## **OCPP 1.6 Errata sheet**

# Errata sheet: for OCPP version: 1.6 edition 2 and 1.6 FINAL.

Figure 1. Sequence Diagram: get diagnostics

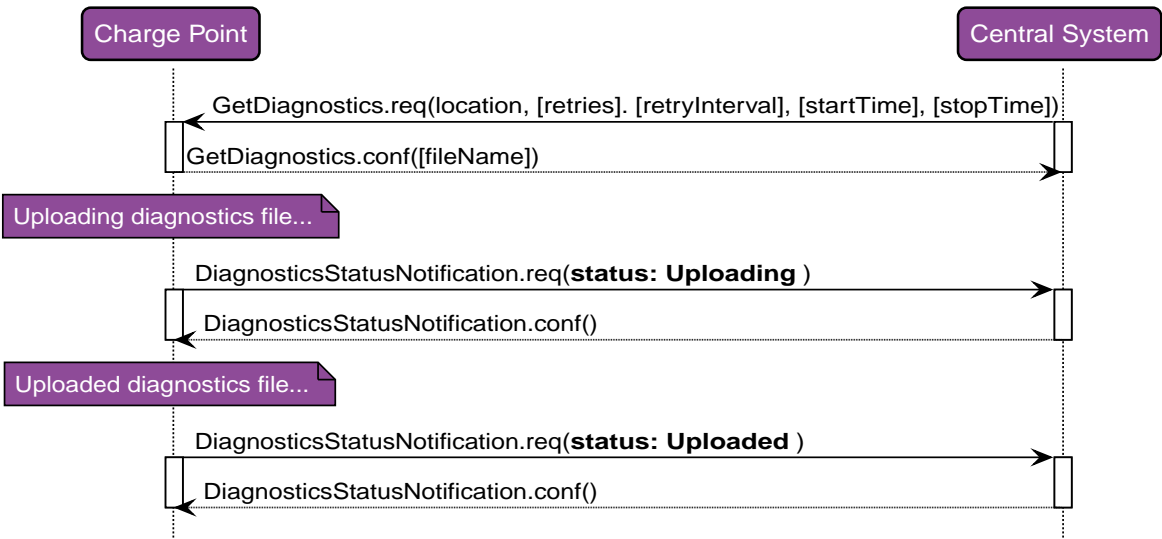
**3.31. Page 51, section: 5.9: Relation between GetDiagnostics.req and DiagnosticsStatusNotification.req is missing.**

There is no description about the relation between GetDiagnostics.req and DiagnosticsStatusNotification.req in the specification.

The following diagram should replace the diagram in 5.9.

Additional text	During uploading of a diagnostics file, the Charge Point MUST send DiagnosticsStatusNotification.req PDUs to keep the Central System updated with the status of the upload process.
-----------------	---

Figure 2. Sequence Diagram: firmware update

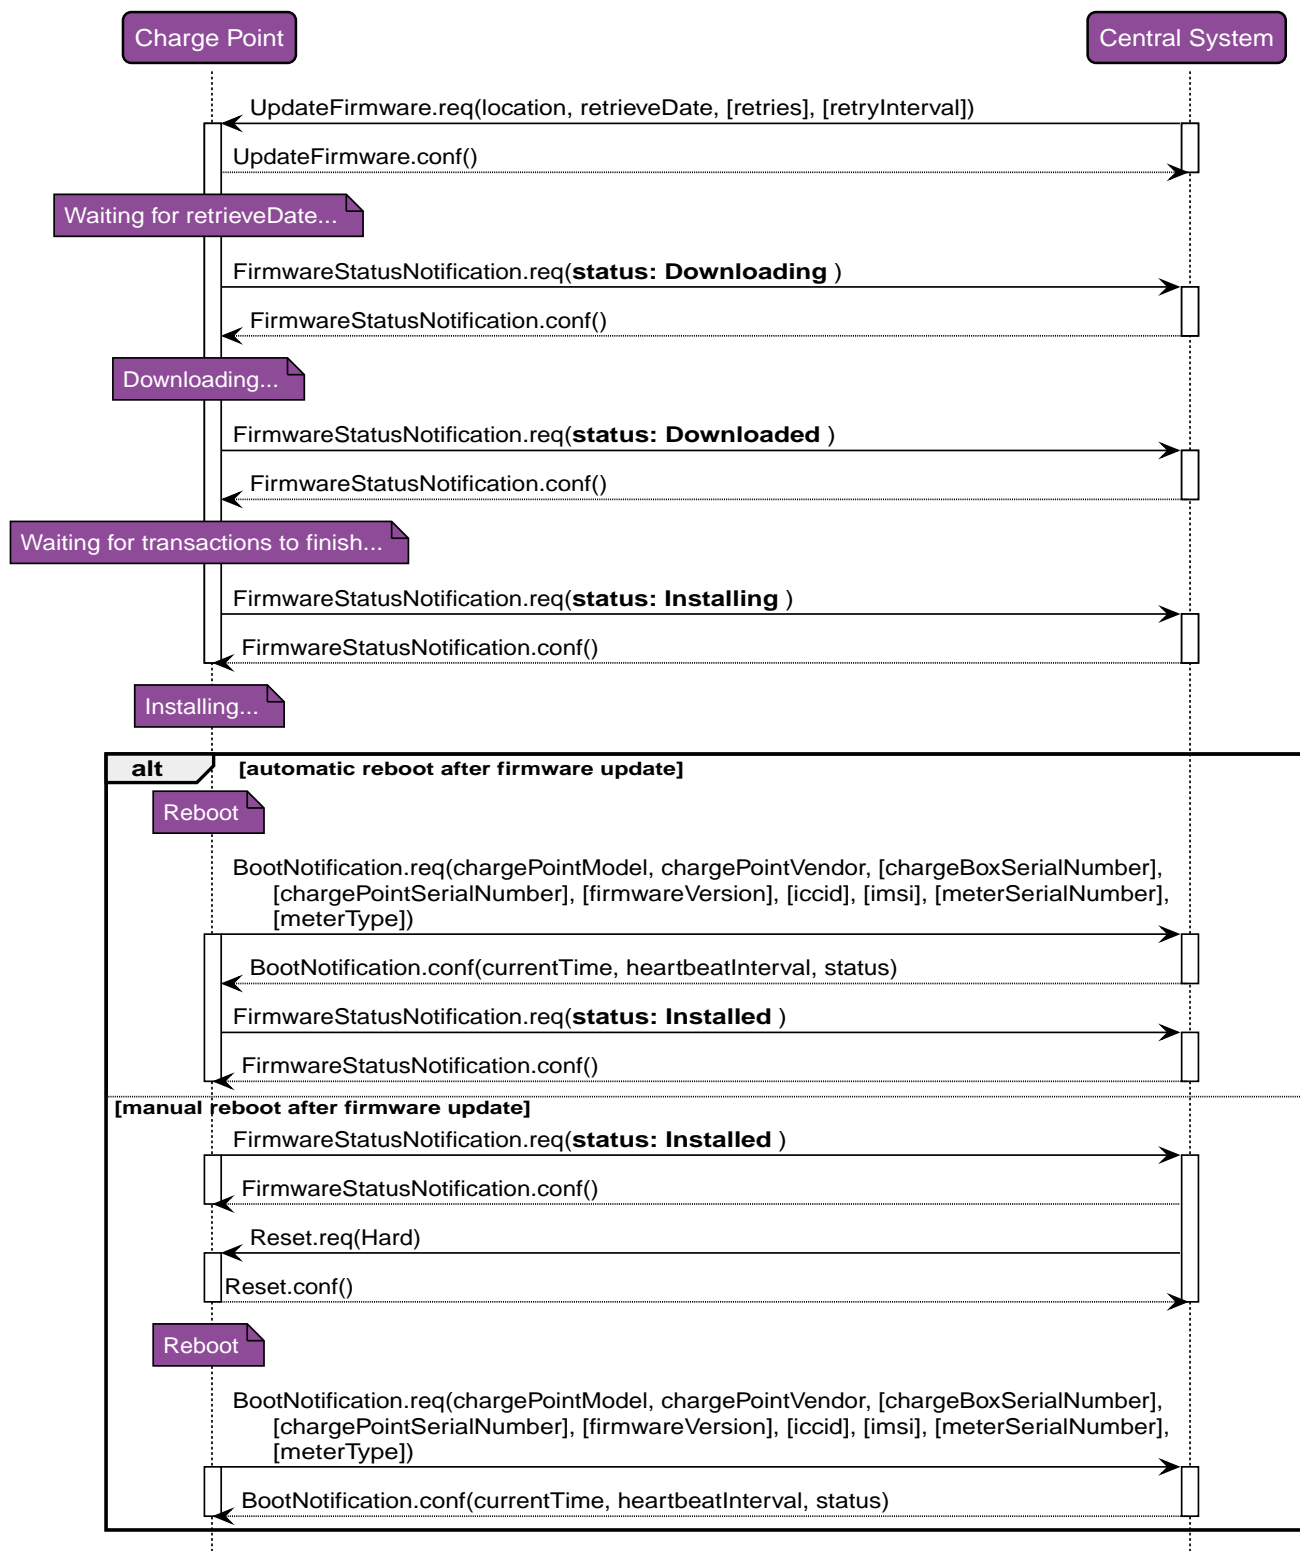
There is no description about the relation between FirmwareUpdate.req and FirmwareStatusNotification.req in the specification. In paragraph 3.3 on page 15, there is a more elaborate diagram of firmware update, including the relationship between UpdateFirmware.req and FirmwareStatusNotification.req, but that paragraph is informative.

The following diagram should replace the diagram in 5.19.

Additional text	<p>During downloading and installation of the firmware, the Charge Point MUST send FirmwareStatusNotification.req PDUs to keep the Central System updated with the status of the update process.</p> <p>The sequence diagram above is an example. It is good practice to first reboot the Charge Point to check the new firmware is booting and able to connect to the Central System, before sending the status: <b>Installed</b>. It is not a requirement.</p>
-----------------	--

Figure 3. Updated Sequence Diagram: Clear Charging Profile

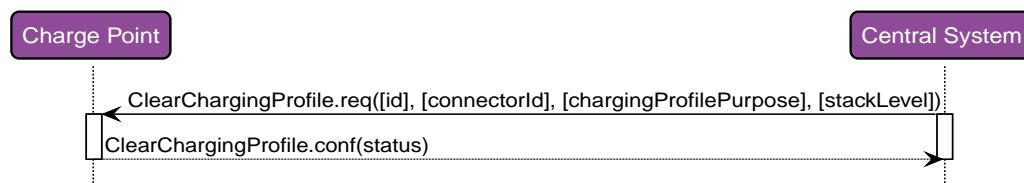
The sequence diagram on page 50 for Clear Charging Profile contains a typo. It contains the incorrect response: "ClearCache.conf" instead of "ClearChargingProfile.conf"

Update diagram for section: 5.5 on page 50:
